UNITED STATES PATENT AND TRADEMARK OFFICE

| APPLICATION NO. | FILING DATE | FIRST NAMED INVENTOR  | ATTORNEY DOCKET NO. | CONFIRMATION NO. |
|-----------------|-------------|-----------------------|---------------------|------------------|
| 09/929,565      | 08/14/2001  | Jean-Francois Barault | ETH1475             | 9842             |

**Office Action Summary**

**FIG. 2**

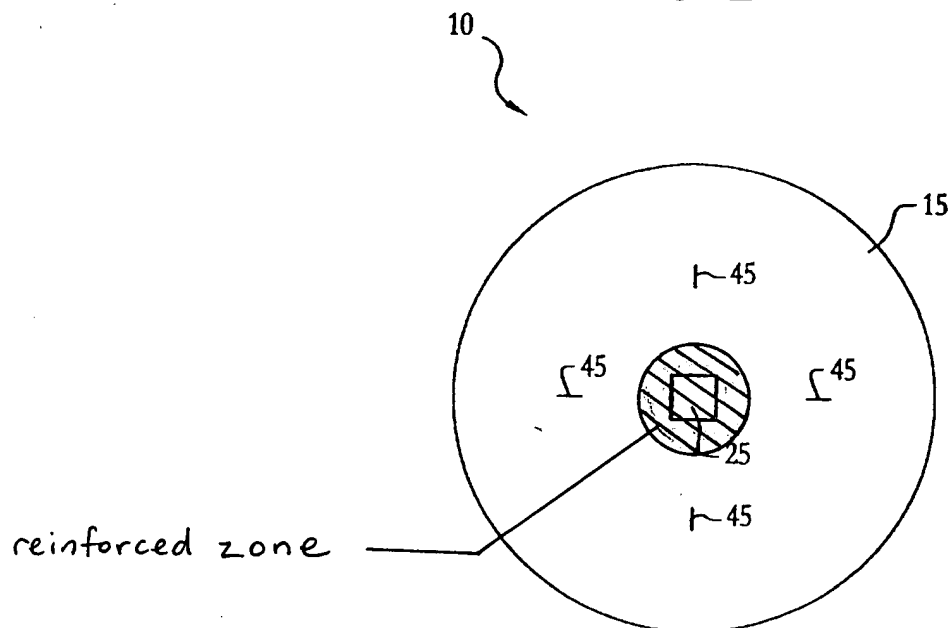
8. Claims 1-5, and 7-12 are rejected under 35 U.S.C. 102(a) as being anticipated by U.S. Patent No. 6,066,776 to Goodwin et al. Regarding Claims 1-3, Goodwin discloses

an areal implant (10) with a mesh-like basic structure (15) and a reinforced zone (labeled in FIG. 2 below) in a central area of the basic structure. The strength of the said reinforced zone decreases towards the peripheral area. Clearly, the reinforced zone will be stronger than the peripheral area of the basic structure, as there is an extra layer of mesh in the reinforced zone [Column 3, lines 41-46]. The reinforced zone (black diagonal lines in FIG. 2 below) has a homogenous central area (25) and a zone (yellow area in FIG. 2 below) of lower strength surrounding the homogenous central area.

9. Regarding Claim 4, Goodwin's reinforced zone (black stripes in FIG. 2 above) is made out of mesh and will have a smaller pore size than the peripheral area of the basic structure (15). The homogenous central area (25) in the reinforced zone of Goodwin's implant (10) consists of one mesh laid on top of another piece of mesh [Column 3, lines 41 to 48]. When adding a sheet of fabric on top of another sheet of fabric, inevitably the fibers of the two fabrics will not line up perfectly, i.e. some of the fibers of the upper

fabric will be located above the pores (interstices) of the fabric below, or vice versa. In other words, the pore size will be decreased by the addition of a second sheet of mesh. Therefore, the reinforced zone in Goodwin's mesh will have a smaller pore size than the peripheral area of the basic structure.

10. Regarding Claim 5, Goodwin discloses an implant, containing all of the limitations of Claims 1-4, in which radial reinforcing elements (45) extend from the reinforced zone towards the peripheral edge of the basic structure (15) [Columns 3, lines 66-67; Column 4, lines 1-8; Column 4, lines 24-26].

[Source: US Patent  
No. 6,391,060 B1  
to Ory et al.]

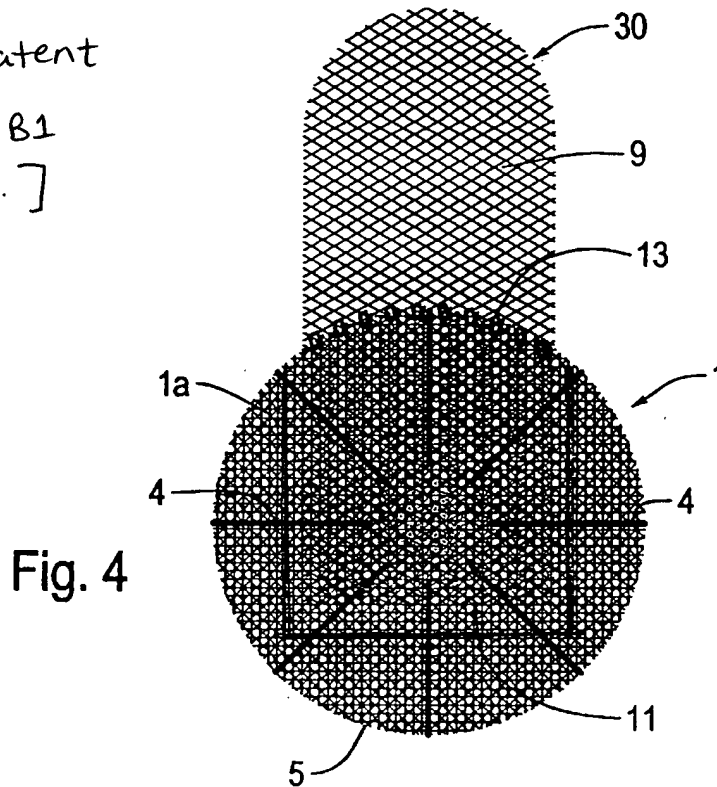
16. Claims 1-7 are also rejected under 35 U.S.C. 102(e) as being anticipated by U.S. Patent No. 6,391,060 to Ory et al. Regarding Claims 1-3, Ory discloses an areal implant (1) with a mesh-like basic structure (1a) and a reinforced zone (inside of red line in below Fig. 4) in a central area of the basic structure. The strength of the said reinforced zone decreases towards the peripheral area. Clearly, the reinforced zone will be stronger than the peripheral area of the basic structure, as there is an extra layer of mesh in the reinforced zone (as shown in Fig. 4 below). The reinforced zone (inside red lines) has a homogenous central area (colored yellow in Fig. 4) and a zone (area between red line and outer edge of panel 9) of lower strength surrounding the homogenous central area.

17. Regarding Claim 4, Ory's reinforced zone (inside of red lines in above Fig. 4) is made out of mesh and will have a smaller pore size than the peripheral area of the basic structure (1a). The homogenous central area (yellow in Fig. 4) in the reinforced zone of Ory's implant (1) consists of one mesh laid on top of another piece of mesh [Column 5, lines 5-17]. When adding a sheet of fabric on top of another sheet of fabric, inevitably the fibers of the two fabrics will not line up perfectly, i.e. some of the fibers of the upper fabric will be located above the pores (interstices) of the fabric below, or vice versa. In other words, the pore size will be decreased by the addition of a second sheet of mesh.

Therefore, the reinforced zone in Ory's mesh will have a smaller pore size than the peripheral area of the basic structure.

18. Regarding Claim 5, Ory discloses an implant, containing all of the limitations of Claims 1-4, in which radial reinforcing elements (4) extend from the reinforced zone towards the peripheral edge of the basic structure (1a) [see Fig. 4].

19. With respect to Claim 6, Ory shows an implant according to the applicant's invention, including at least one radial reinforcing element (4) that is widened in the area of the peripheral edge (5) of the basic structure (1a). The radial reinforcing elements and the discontinuous over stitching (8), as divulged by Ory, are made out of the *same thread* and therefore the over stitching is merely an extension—a widened area—of each radial element [Column 4, lines 17-20 and lines 54-58]. Because the radial reinforcing elements *intersect* the over stitching (8) and the two are made from an identical substance, one would say that the over stitching (8) is merely a widened area of each radial reinforcing element.
